STAFF REPORT 03-13-2024 MEETING

APPLICATION NUMBER: HDC2024-00089

ADDRESS: 477 WEST ALEXANDRINE

SCOPE: ERECT MULTI-FAMILY BUILDING WITH REAR PARKING LOT

Application submissions, including site plan (above), front elevation (below left), and side/rear elevations (below right). Note side/rear elevations are proposed to be metal panel. Images not to scale.

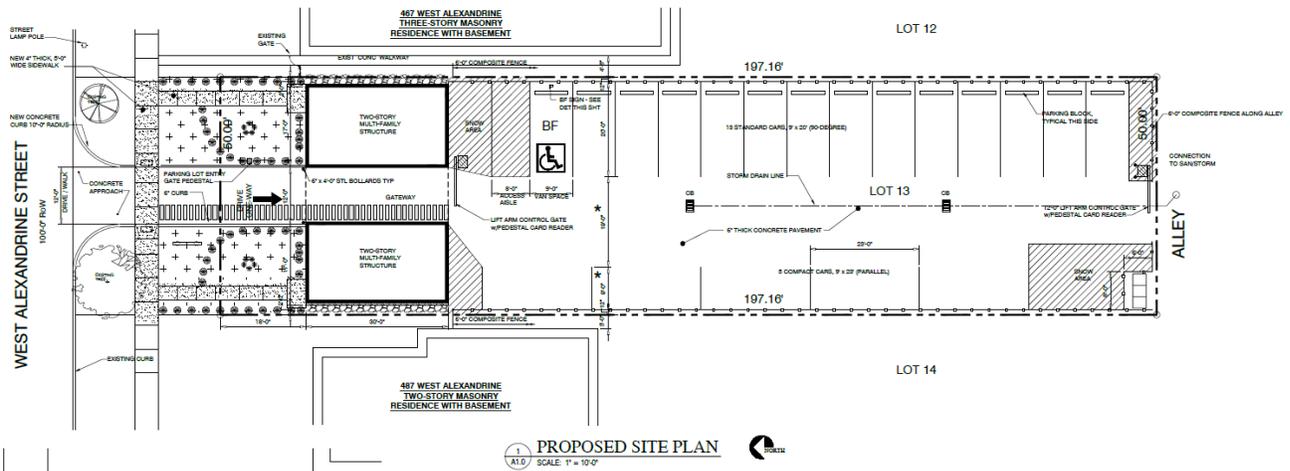
- The building's scale and lot coverage is still somewhat small.
 - The site fence should be wood, metal, masonry, or other traditional material instead of vinyl.

- In staff’s opinion, the parking lot should remain visually subordinate to the building, concealed from view, and should not exist separately from the building. The lot should be constructed only after the building is completed.

- Windows will be standard vision glass, designed either as subdivided casement windows or 1/1 double-hung style windows in mulled sets.
- The site fence will be wood, metal, masonry, or other traditional material instead of PVC, in a design appropriate for the context.
- The parking lot will remain visually subordinate to the building, concealed from view, and shall not exist separately from the building. Permit application will only be approved by staff for a single project (including both the building and the parking lot) constructed in a single phase.

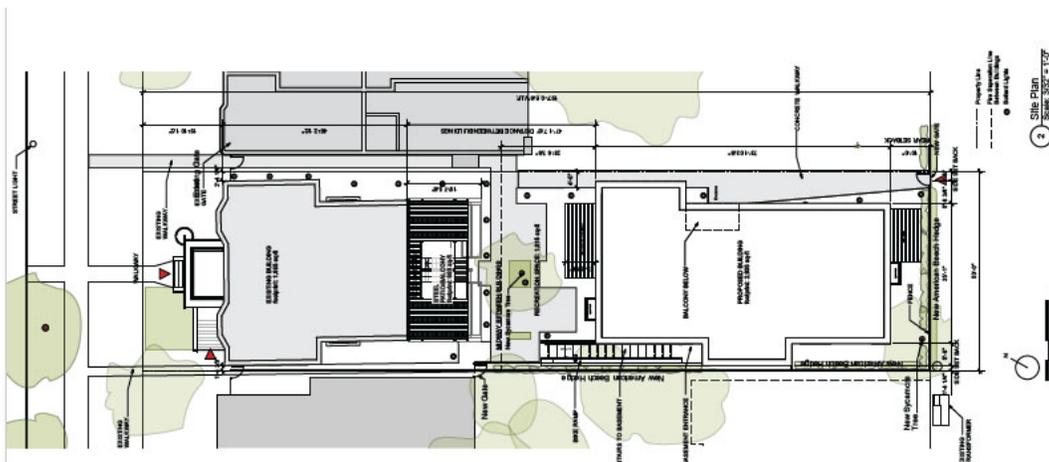
Rendering of revised project design provided by the applicant, with brick façade. Note the applicant has informed staff that they will revise the single-pane casement windows to 1/1 windows to add additional texture and articulation to the window openings, though such revision has not been submitted yet. The brick-clad design is the only application offered for the Commission's review at this time, per the applicant.

- In discussions with the applicant on Wednesday, March 6th, the applicant decided to revise their design to incorporate 1/1 windows instead of undivided casements. In staff's opinion, such a revision would introduce a satisfactory level of articulation and texture to the proposed windows. Alternately, the single-pane casements could have been subdivided with true or simulated divided lites.
